Forest  
Service

Coconino  
National Forest,  
Supervisor's Office

### 4FRI BOARD MEMO

To: 4FRI Board  
From: Jeremy Kruger, CE 4FRI  
RE: SPLYT/SALT  
Date: 1/5/21

#### ***Outcome of Recommended Revision***

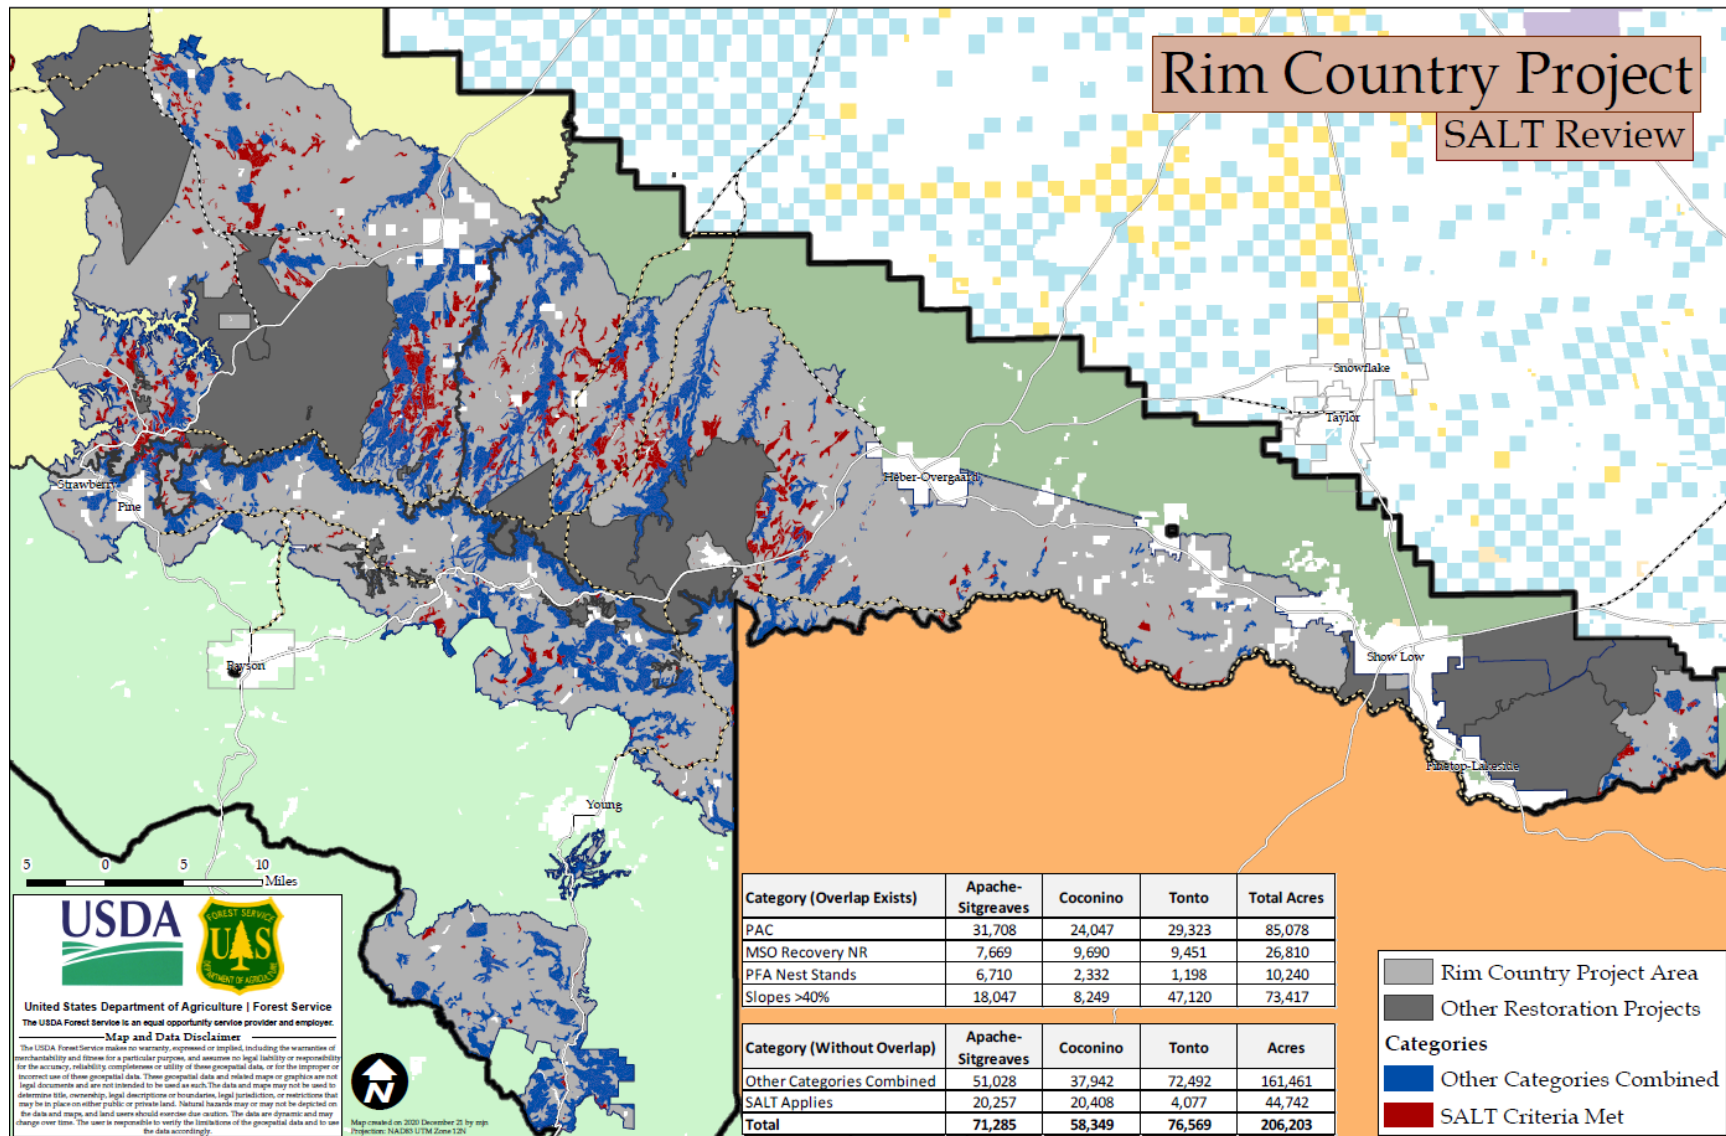
There is concern regarding the number of acres that will result in closed canopy conditions post-treatment in the Rim Country EIS. The table below quantifies these acres as a result of PAC, MSO Recovery NR, PFA nest stand and steep slope conditions. Considering overlap of these conditions (e.g. some acres are PACs on steep slopes), closed canopy conditions **may** occur on ~161,000 acres across the project area. However it is important to note that not all of these acres will result in

closed canopy conditions. For example, most of the ~47,000 acres of steep slopes on the TNF fall just below the rim and are not vegetated. Some of the other acres (PACs, MSO Recovery and PFA nest stands) currently have open canopies and will not result in closed canopy conditions post-treatment.

Approved of the revised definition of SALT will result in an additional ~44,700 acres in closed canopy conditions across the three forests. The recommended revision does not include a limit or cap on the number of acres that could be identified as SALT. Though stand data indicates this to be ~44,700 acres, the number of acres that meet this definition could be greater or lesser than this estimate.
